Access Compliance Report

Public Rights-of-Way

(Curb Ramps)

Intersection ID: 10033355	Main Street: OLD_ARDREY_KELL_RD	Cross Street: N/A	Location: SE
ADA ID: 2E3A49F1417D	Ramp Type: Perp	Initial Pass/Fail: Fail	Overall Compliance: No
Severity Score: 21.25			
Codes/Mitigation Info/Possible Solution		Field Measurements/Component Compliance

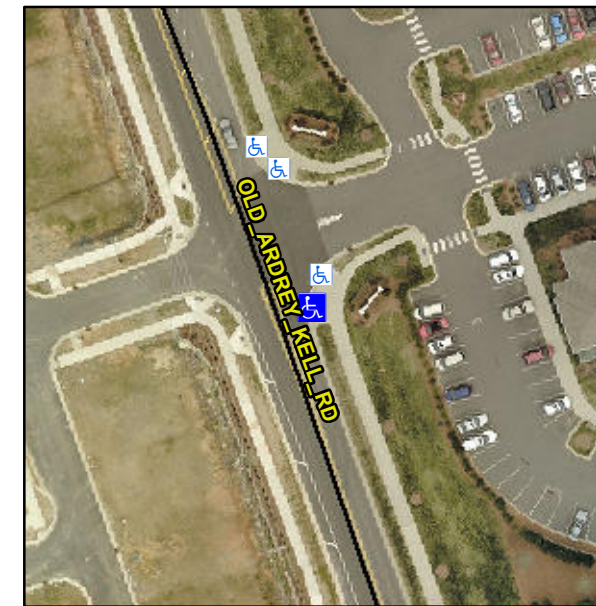
Not Found, R304.5.1, R304.2.2

Compliance	Description	Data	Compliance	Description	Data
N/A	Ramp Length (in)	106.0	No	Ramp Slope (%)	9.2
No	Ramp Width (in)	47.0	Yes	Ramp XSlope (%)	0.2
N/A	Flare Type LT	N/A	N/A	Flare Type RT	N/A
N/A	Flare Slope LT (%)	N/A	N/A	Flare Slope RT (%)	N/A
N/A	Flare Traversable LT?	N/A	N/A	Flare Traversable RT?	N/A
N/A	Landing Length (in)	N/A	N/A	DWS Provided?	N/A
N/A	Landing Width (in)	N/A	N/A	DWS Contrast?	N/A
N/A	Landing Slope (%)	N/A	N/A	DWS Length (in)	N/A
N/A	Landing X Slope (%)	N/A	N/A	DWS Full Width?	N/A
N/A	Landing Curb? (Y/N)	N/A	N/A	DWS Offset (in)	N/A
N/A	Shared Landing?	N/A			
N/A	Gutter Ponding?	N/A	N/A	Gutter Slope (%)	N/A
N/A	Gutter Lip Ht (in)	N/A	N/A	Gutter X Slope (%)	N/A
N/A	Painted X Walk1?	No	N/A	Painted X Walk2?	N/A
	X Walk 1 Direction	To W		X Walk 2 Direction	N/A
N/A	X Walk 1 Width (in)	N/A	N/A	X Walk 2 Width (in)	N/A
	X Walk 1 Slope (%)	1.2		X Walk 2 Slope (%)	N/A
	X Walk 1 X Slope (%)	0.9		X Walk 2 X Slope (%)	N/A

Remove & Replace Entire Ramp.
